**PLANNED UNIT DEVELOPMENT
& SUBDIVISION STAFF REPORT****Date: August 4, 2011****DEVELOPMENT NAME**

Airport Waffle House Subdivision

LOCATION3024 Airport Boulevard
(North side of Airport Boulevard Service Road, 490'±
West of Sage Avenue)**CITY COUNCIL
DISTRICT**

Planned Unit Development Approval to allow multiple buildings on a single building site, with shared access and parking between two building sites, and Subdivision approval to create 2 lots from one metes-and-bounds parcel.

SITE PLAN

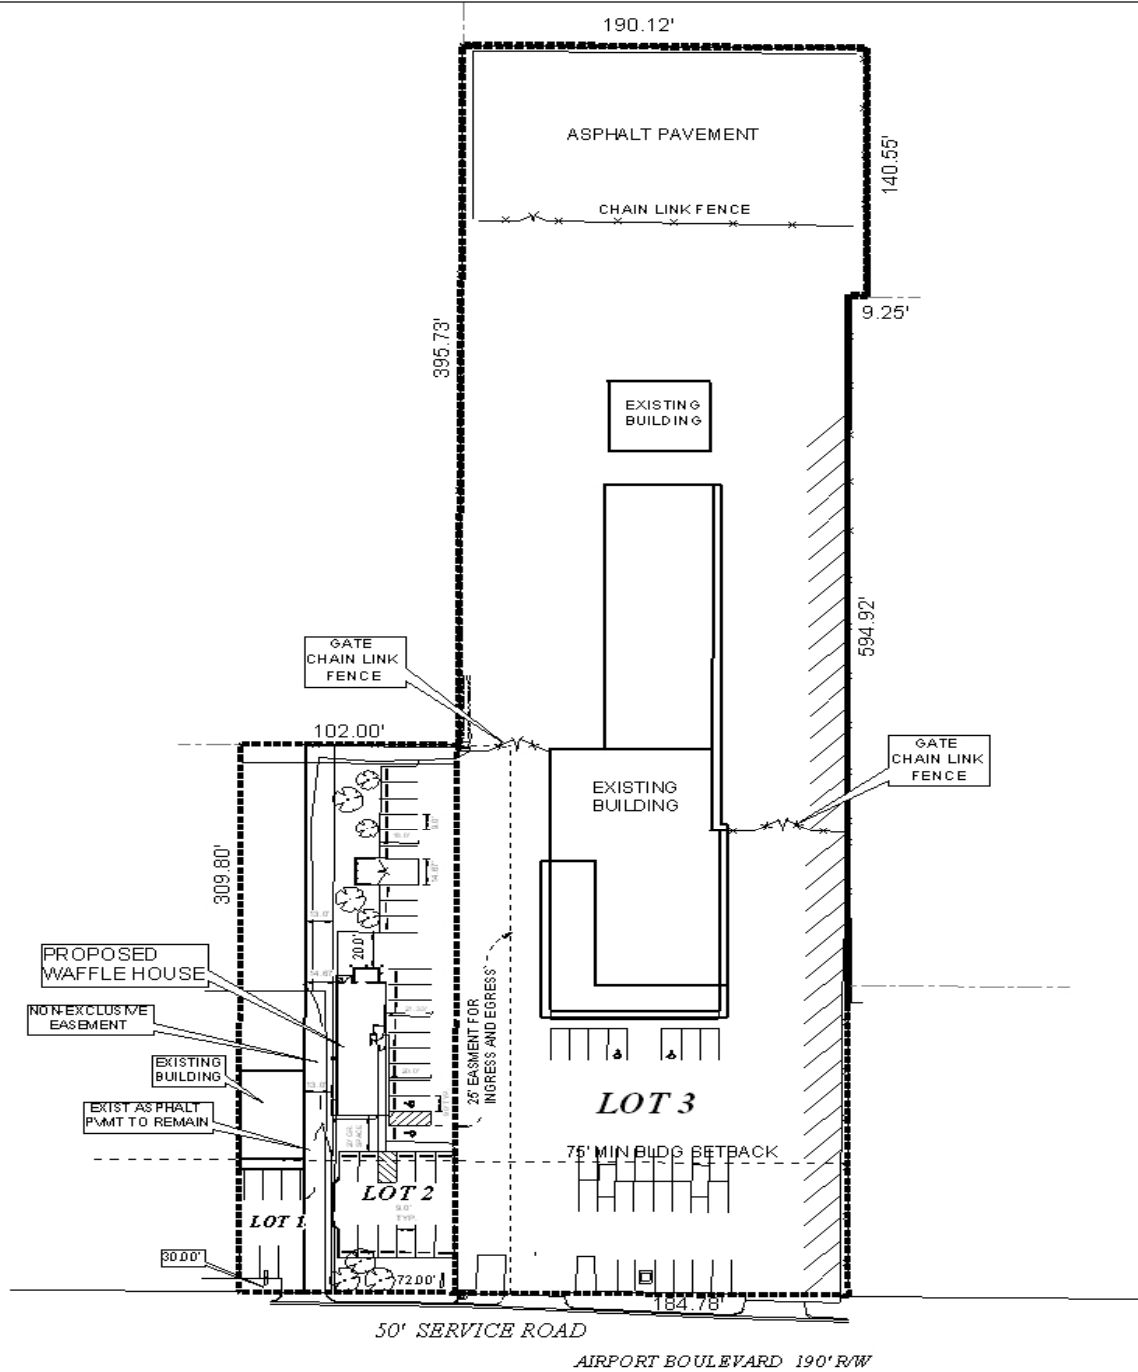
The submitted site plan shows that the applicant wishes to have two existing curb-cuts to remain on Lot 3 with a 25' wide ingress/egress easement illustrated to allow shared access between Lots

2 and 3. There is also an existing shared curb-cut proposed to remain between Lots 1 and 2 with a 13' wide ingress/egress easement to allow the owner of Lot 1 access to the rear of his property. If approved, a note should be placed on the Final Plat limiting Lots 1 and 2 to one shared curb-cut to Airport Boulevard Service Road, and Lot 3 limited to 2 curb-cuts to Airport Boulevard Service Road with the size, design, and location of all curb-cuts to be approved by City of Mobile Engineering and conform to AASHTO standards.

It should be noted that while no parking information is provided, it appears that all three lots will have at least the minimum amount of required parking. If approved, a revised PUD site plan should be submitted with parking calculations.

It should also be noted that the only lot that illustrates a dumpster on-site is Lot 2. If approved, a revise PUD site plan should be submitted illustrating dumpsters on all lots, or placement of a note on the revised site plan stating that curb-side service is used.

- 1) inclusion of parking data;
- 2) retention of landscaping and tree planting information;
- 3) placement of required Live Oak frontage trees in right-of-way with right-of-way permits for Lots 1 and 3;
- 4) revision of the site plan to illustrate a proper 10' wide vegetative or 6' privacy fence buffer in compliance with Section V.A.8. of the Subdivision Regulations;
- 5) provision of a dumpster for each building, screened from view and in compliance with Section 64-4.D.9 of the Zoning Ordinance, or the placement of a note on the site plan stating that garbage collection will be curb-side via a private pick-up service and no dumpster will be utilized; and
- 6) provision of two (2) revised site plans to the Planning Section of Urban Development.

DETAIL SITE PLAN

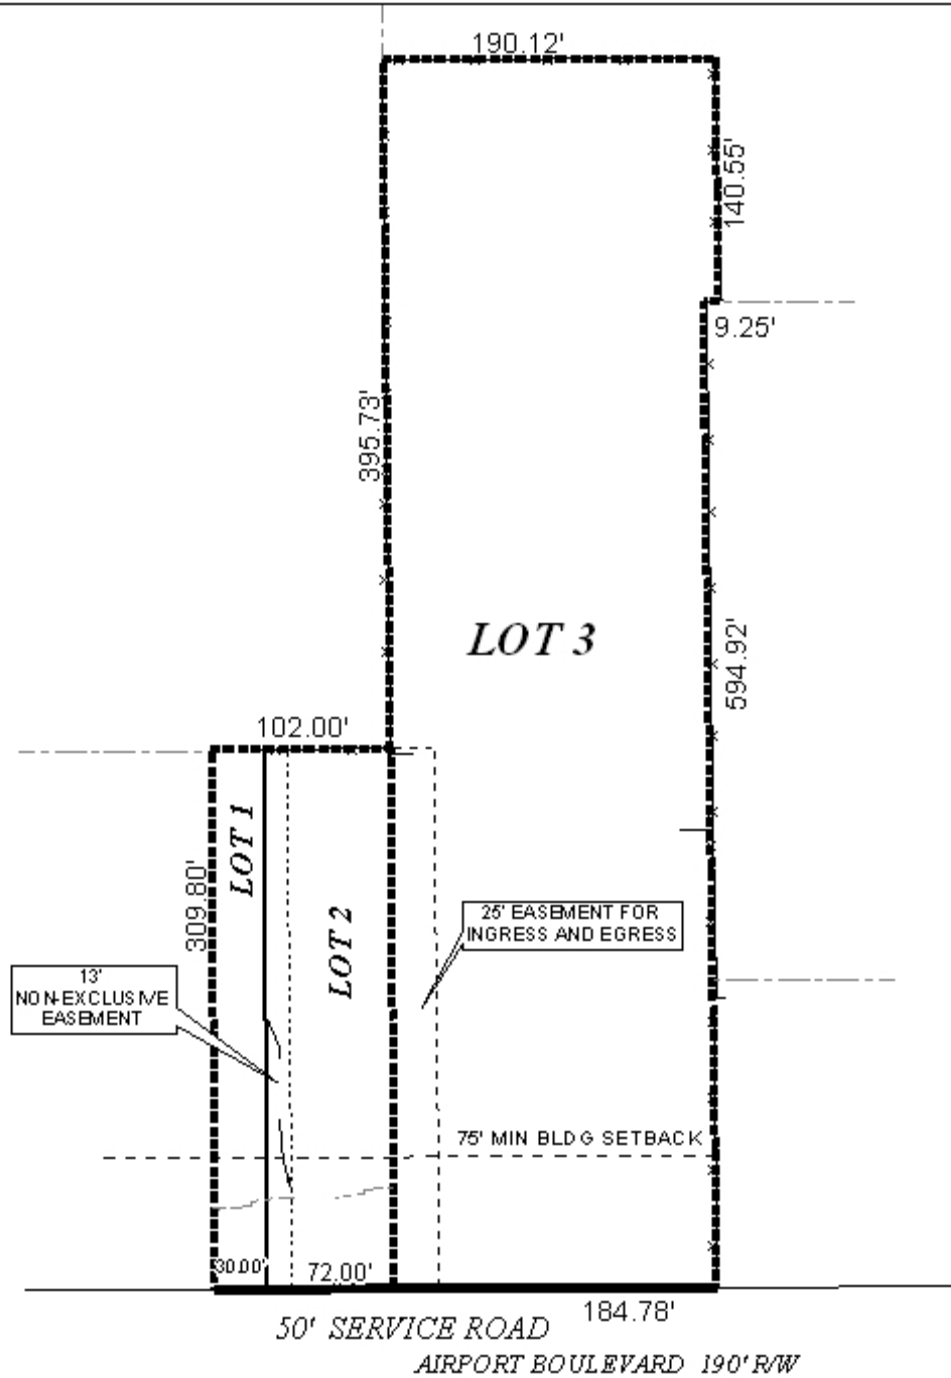
It is important to note that of the three proposed lots; only Lot 2 is currently proposed to be redeveloped. At such a time as the owners of Lot 1 and Lot 3 decide to redevelop these lots, full compliance will be required with all municipal codes and ordinances. However, all lots will be required to provide frontage Live Oak trees. Because both Lots 1 and 3 do not have adequate landscaping area to plant these trees, it is the recommendation of Urban Forestry that the trees be placed in the right-of-way with an approved right-of-way permit. As the Planned Unit Development is proposed with several common interior property lines, staff has in the past allowed these interior property lines not be counted as perimeter lot lines, but rather look at the overall Planned Unit Development (PUD). With this in mind, Lot 2 illustrates full compliance with tree and landscaping requirements.
